## First Revision No. 8978-NFPA 70-2018 [ Global Input ]

### Change Title of Article 555 to Marinas, Boatyards, Floating Buildings and Commercial and Noncommercial Docking Facilities

## Article 555

### Marinas, Boatyards, Floating Buildings and Commercial and Noncommercial Docking Facilities

**Figure 550.10(C) 50-Ampere, 125/250-Volt Receptacle and Attachment Plug Cap Configurations, 3-Pole, 4-Wire, Grounding-Types, Used for Mobile Home Supply Cords and Mobile Home Parks.**

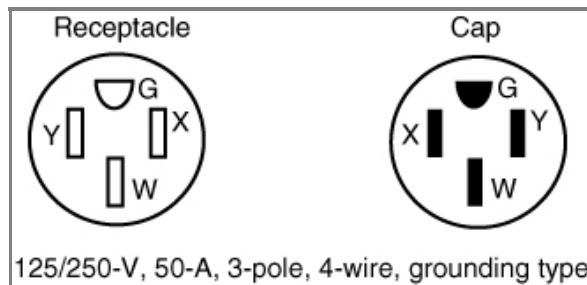
Informational Note: Complete details of the 50-ampere plug and receptacle configuration can be found in ANSI/NEMA WD 6-2002 (R2008) 2016 , *Standard for Dimensions of Attachment Plugs and Receptacles Wiring Devices — Dimensional Specifications* , Figure 14-50.

**Figure 551.46(C)(1) Configurations for Grounding-Type Receptacles and Attachment Plug Caps Used for Recreational Vehicle Supply Cords and Recreational Vehicle Lots.**

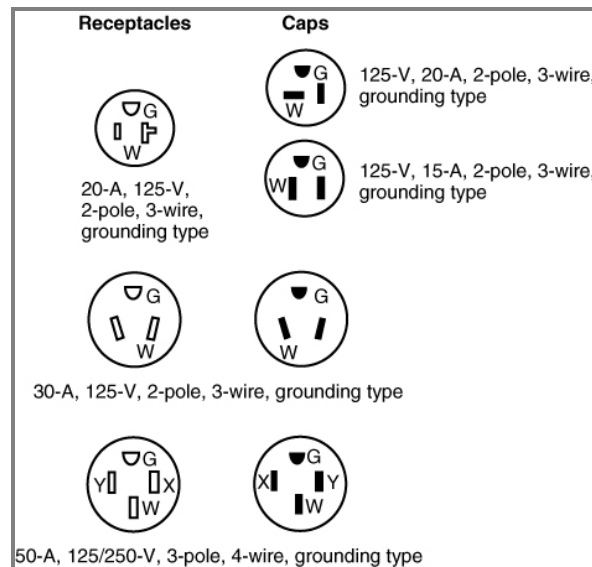
Informational Note: Complete details of this configuration can be found in ANSI/NEMA WD 6-2002 2016, *Standard for Dimensions of Attachment Plugs and Receptacle Wiring Devices — Dimensional Specifications*, Figure 5.15.

**Figure 552.44(C)(1) Attachment Cap and Receptacle Configurations.**

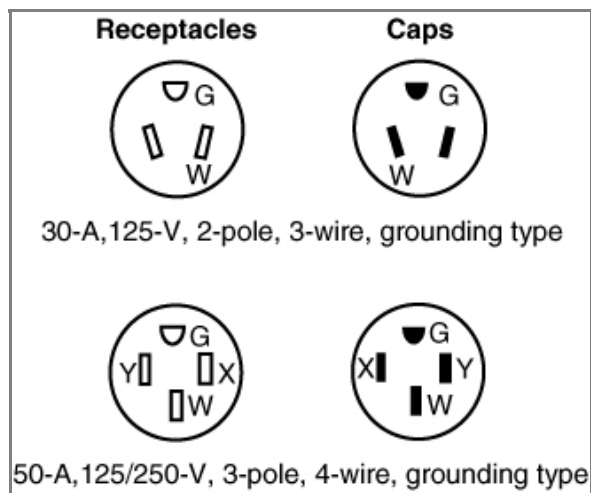
Informational Note: Complete details of this configuration can be found in ANSI/NEMA WD 6-2002 (Rev. 2008) 2016, *Standard for Dimensions of Attachment Plugs and Receptacles Wiring Devices — Dimensional Specifications*, Figure 14-50.
